A D D E N D U M N O . 2

Project: EOU Ballfield Complex
RFP #: #FP-2022-09B
Date: April 7, 2026
Subject: Bid Form & Existing Conditions Plan Addenda

This three (3) page addenda changes the contract documents as follows:
modifies the bid due date to Tuesday April 16, 2026, the package 'A' bid form, and the overall civil grading plan to answer bidder questions.

LC1.01

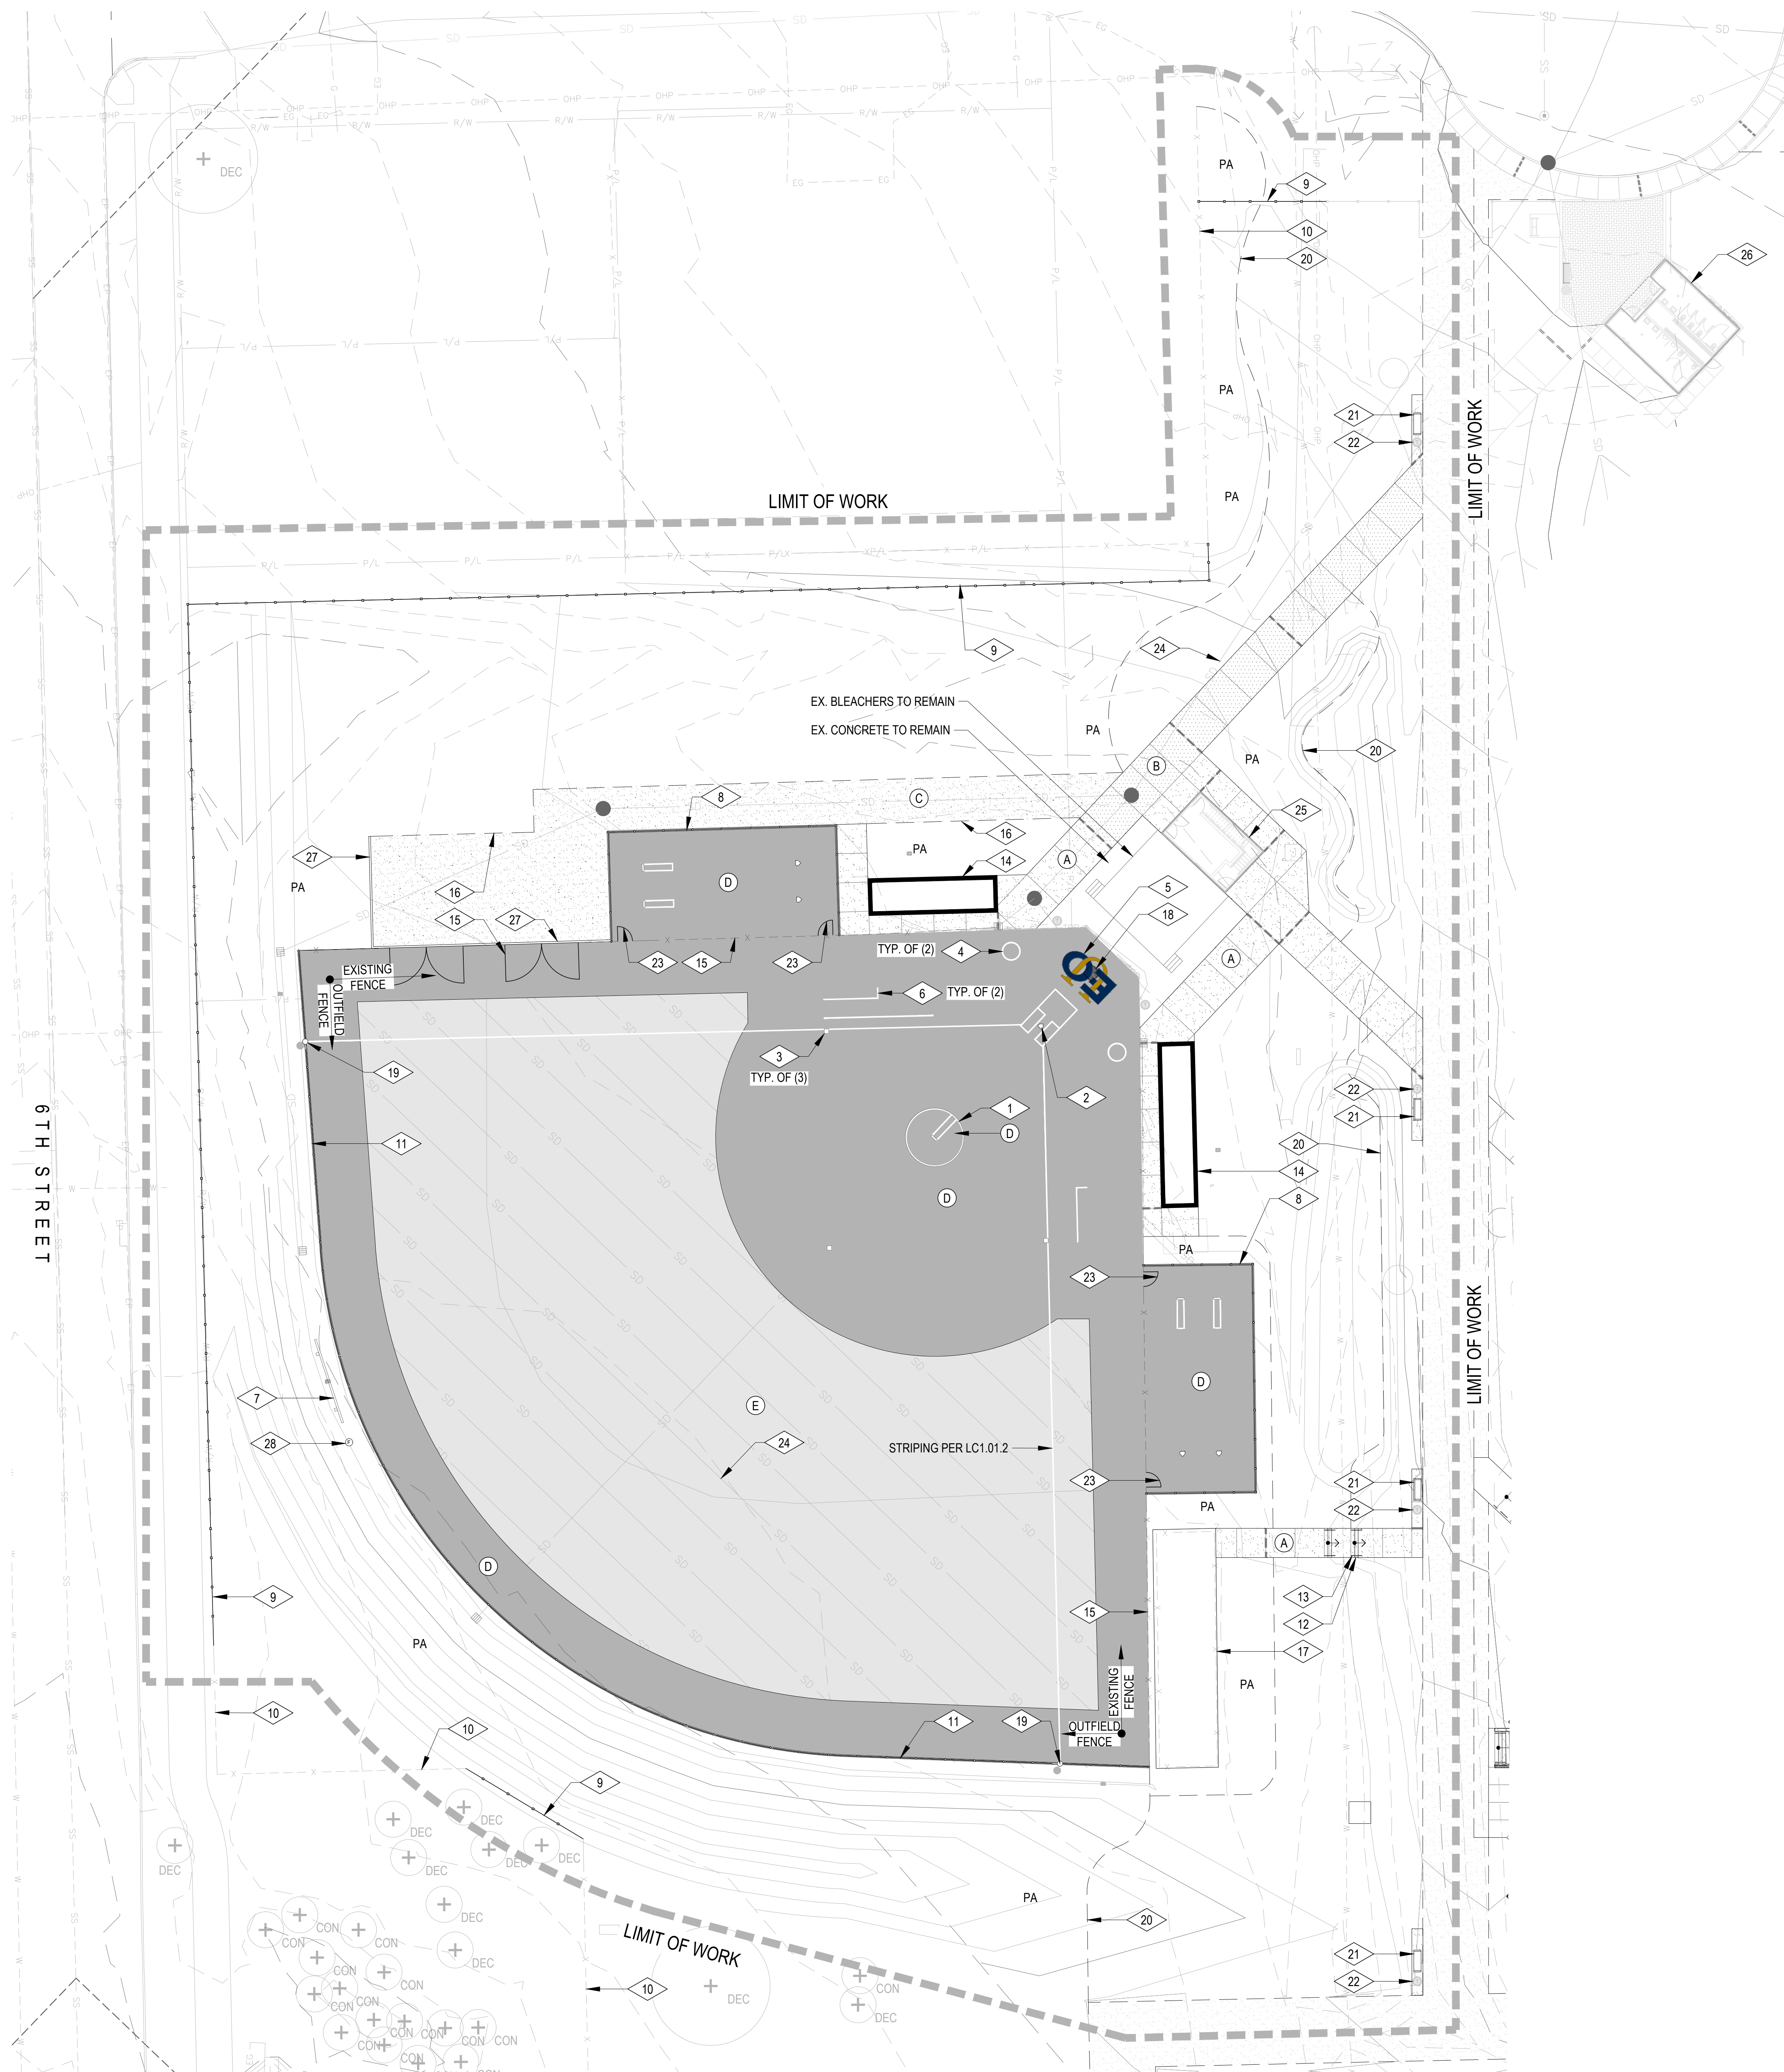
Package C SHEETS LC1.00, LC1.01, LC1.01.2, LC1.02

These sheets have been revised to indicate drawing scale and north arrow.
